## Planning and Zoning Commission Amendments

**TO:** City Council  
**FROM:** Andrea Villalobos, AICP, CNU-A, Senior Planner – Planning and Development Services Department  
**DATE:** February 10, 2021  
**RE:** Planning and Zoning Commission Amendments

**TABLE 4.12 VERTICAL EXPRESSION ELEMENTS**  
 The standards in this table are intended to ensure that vertical expression elements utilized to satisfy the blank wall area standards are of sufficient size and design to meet the intent of the blank wall area requirement.

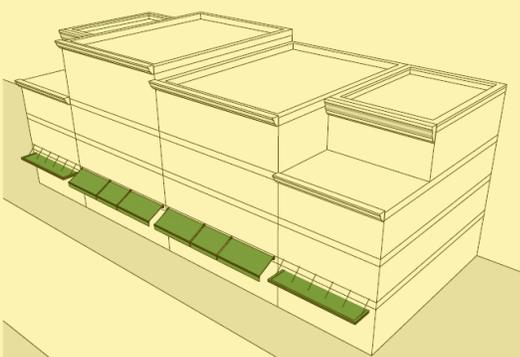
**#2** Development Code: Section 4.3.5.4 Expression Elements, Table 4.13 Horizontal Expression Elements  
 Amendment to Table 4.13 of the Development Code to add in “Awning / Canopy” as a fourth horizontal element in the table.

➔ Insert new row allowing “Awning/Canopy” as a fourth horizontal element in the table.

**Awning / Canopy**  
Description. A wall mounted, cantilevered structure providing shade and cover from the weather for a sidewalk.  
General Requirements:

- An awning/canopy must be a minimum of 9 feet clear height above the sidewalk and must have a minimum depth of 6 feet.
- An awning/canopy may extend into a primary or side street setback.
- An awning/canopy may encroach up to 6 feet into the public right-of-way but must be at least 2 feet inside the curb line or edge of pavement, whichever is
